Your Ref
EG/81/18/HH
Our Ref
PLAN-026262
Date
31/01/2019

Proposal: Proposed conservatory to the rear and side elevation.
Site: 73 Barnham Road, Eastergate, PO22 0EP.
EG/81/18/HH

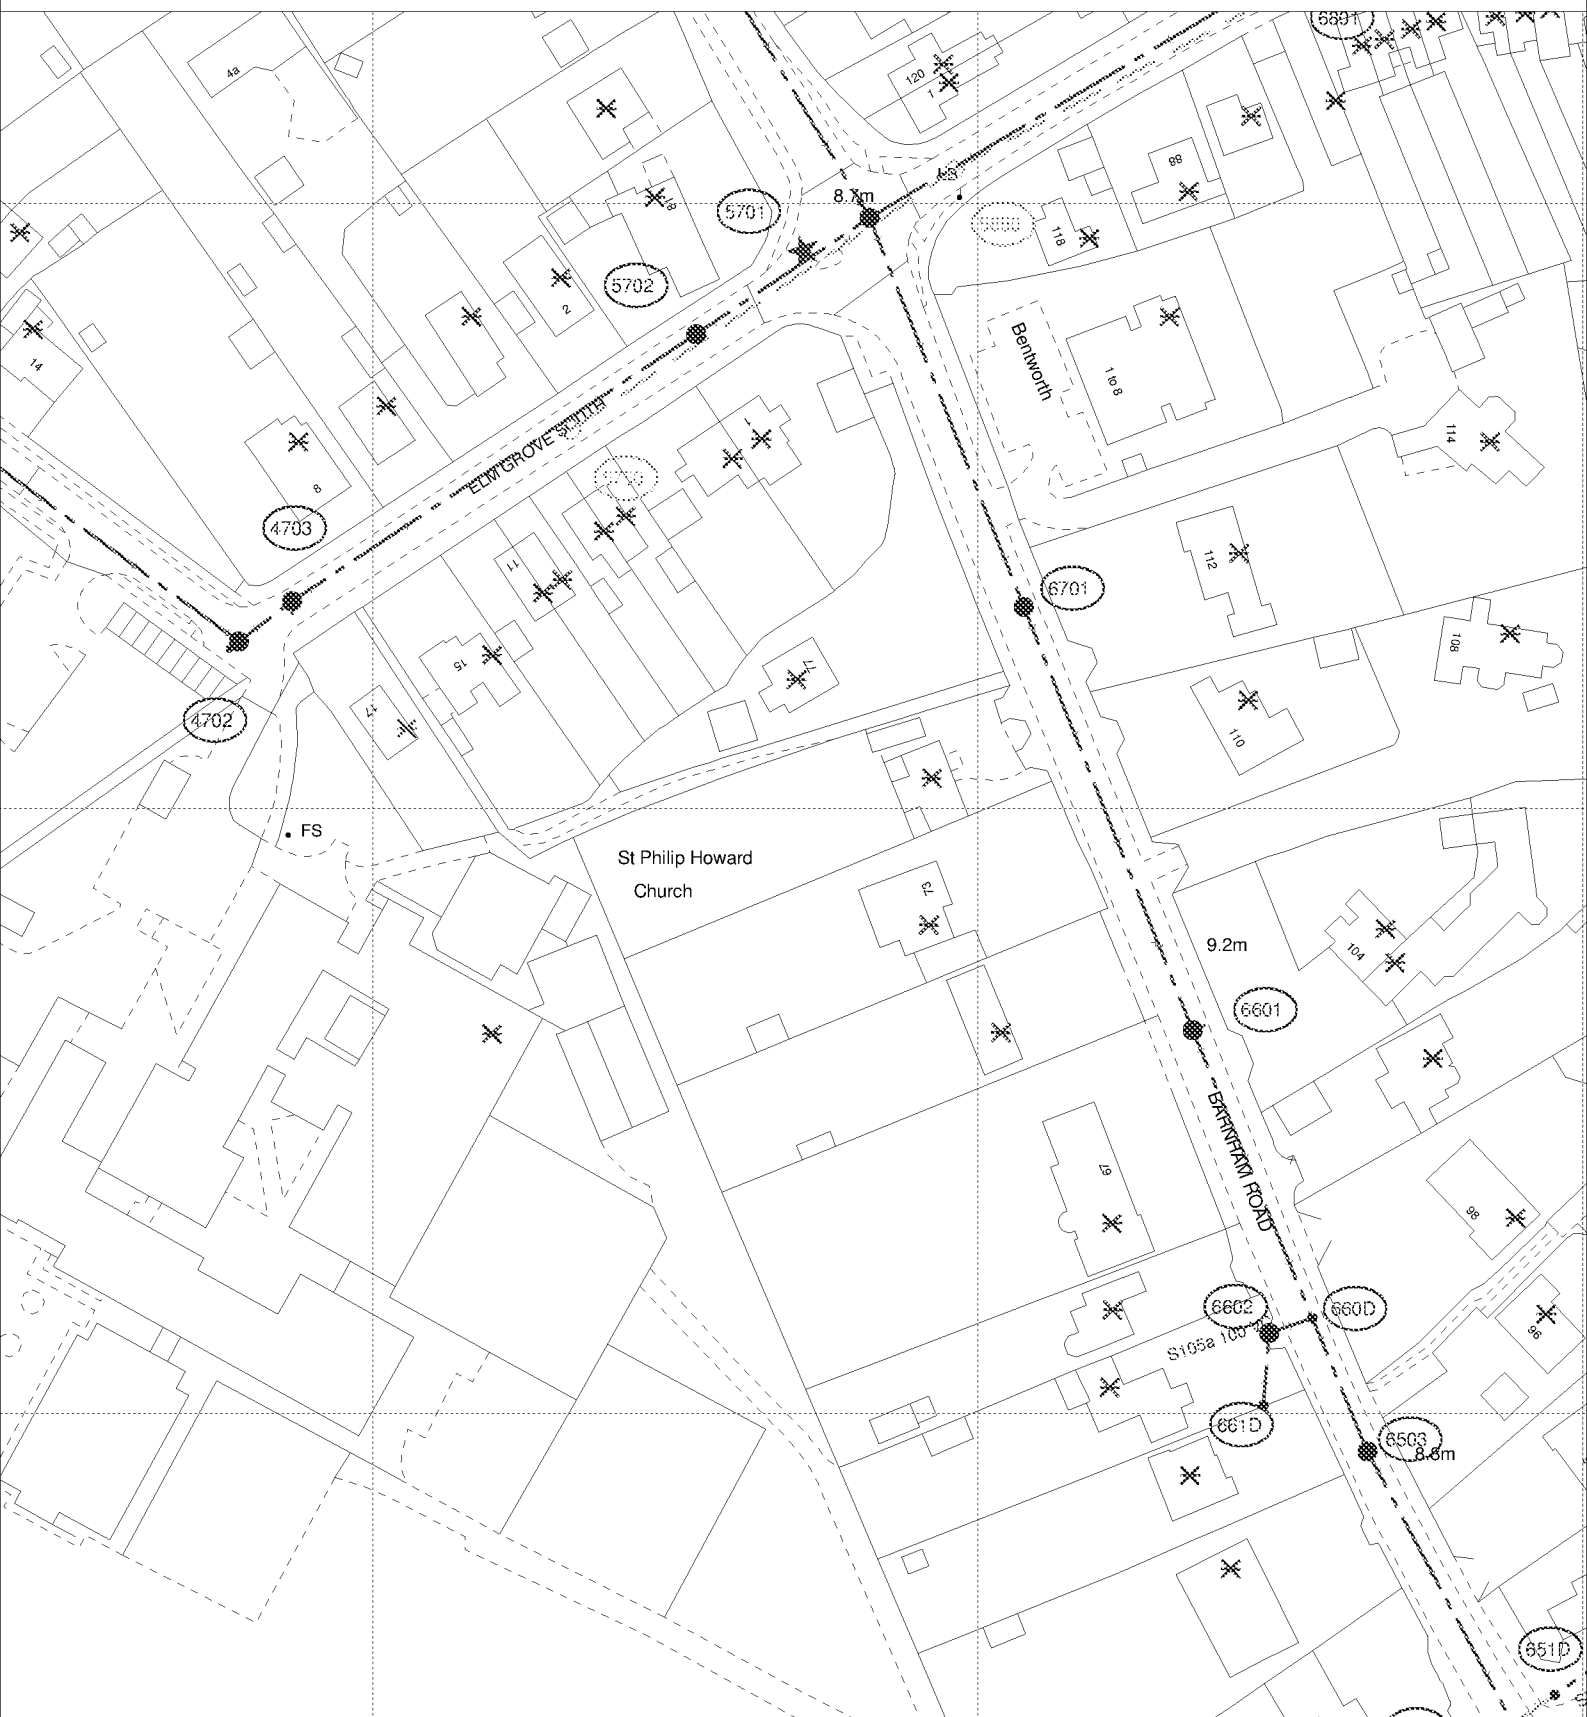
Due to surface water inundation issues in the Lidsey Catchment "The applicant is advised to adopt, where appropriate, the measures in the table "Practical measures to reduce the potential impacts of development".

Developer should look to protect the public sewerage system from inundation and infiltration, which contribute to flooding in unfavourable conditions.
